IEEE 802.3da SPMD: MPoE: **Multiple MPIs per DTE**

Peter Jones, Cisco Systems
May 2025

802.3da D2.2 defines LLDP TLVs for a single MPI per DTE. This document proposes changes to the current clause 30 and clause 79 draft text to support this/

Figure 189-1a – Example MPI to DTE associations

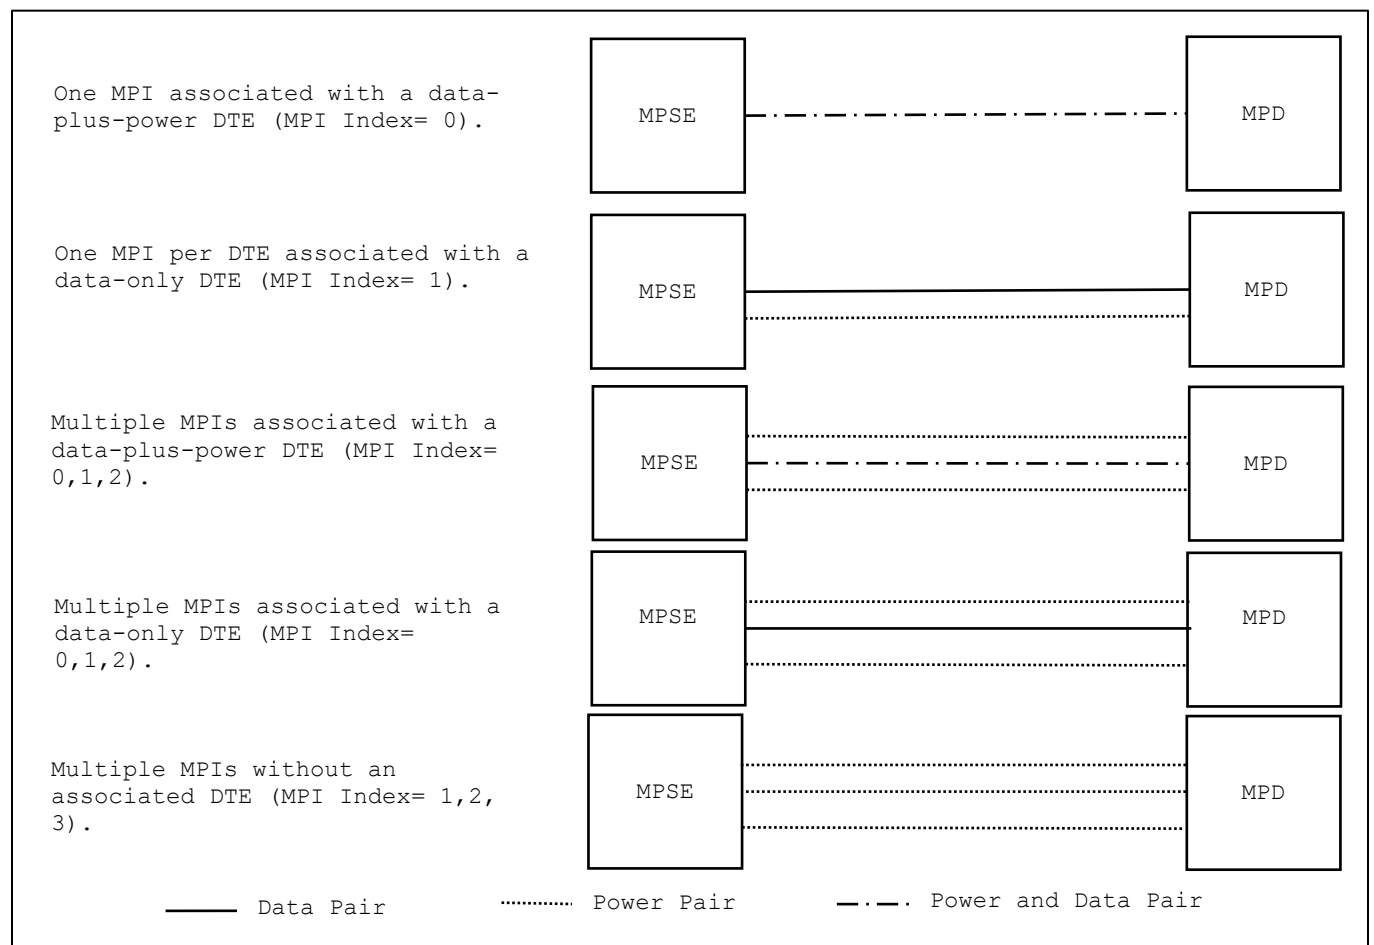
Add the following text after Figure 189–1 in 188.1.2

Figure 189-1a below illustrates some of the different types of MPI and DTE associations supported by MPoE.

189.1.2a.1 MPIs associated with a DTE

A DTE may be associated with 0, 1 or more than one MPIs. A DTE with 0 associated MPIs is a data only link. A DTE often has an MPI sharing the same power/data pair.

The set of MPIs associated with a DTE are identified within the DTE using an MPIIndex. MPIIndex has the following semantics:

- Type: 8 bit unsigned integer
- Values:
 - 0: The MPI that connects to the same physical media as the DTE.
 - >0: = separate MPIs

The set of MPIs associated with a DTE shall meet the following criteria:

- All MPIs for a given DTE are either MPSEs, or MPDs.
- Unless stated otherwise, all other MPI attributes for a given DTE are independent. This includes:
 - MPI type
 - MPI capabilities and status
 - MPI requested and granted power
